Authorized Field Change

AFC 18901

Subject File: ENGINE

Subject: HVAC Condenser

Figure 1. Condenser Isolators

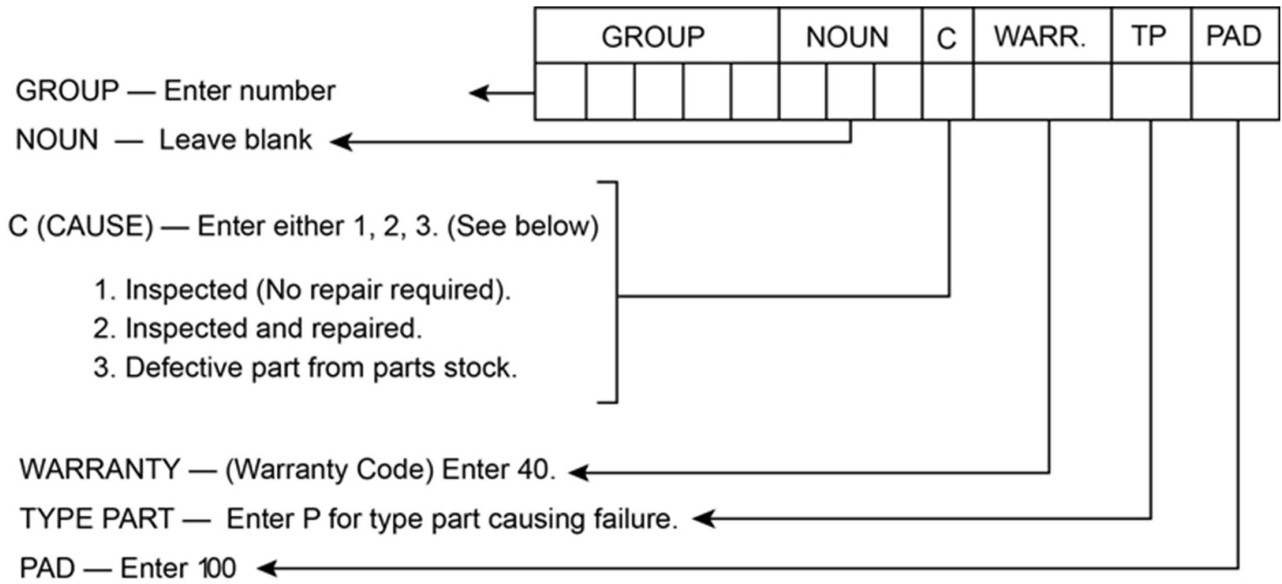
7. Inspect condenser mounting pads.
 - a. If both sides of condenser have rubber isolators / slots for isolators (Figure 1, Item 1 and 2), then condenser does not require replacement. Proceed to Step 12.
 - b. If only driver-side isolator / slots for isolators are found (Figure 1, Item 2), condenser must be replaced. Proceed to Step 8.
8. Recover A/C system, refer to appropriate Service Manual for detailed instructions.

9. Remove A/C condenser, refer to appropriate Service Manual for detailed instructions.

NOTE: The new condenser comes with 4 new rubber isolators. Do not reuse the rubber isolators from the old condenser.

10. Install new condenser, refer to appropriate Service Manual for detailed instructions.
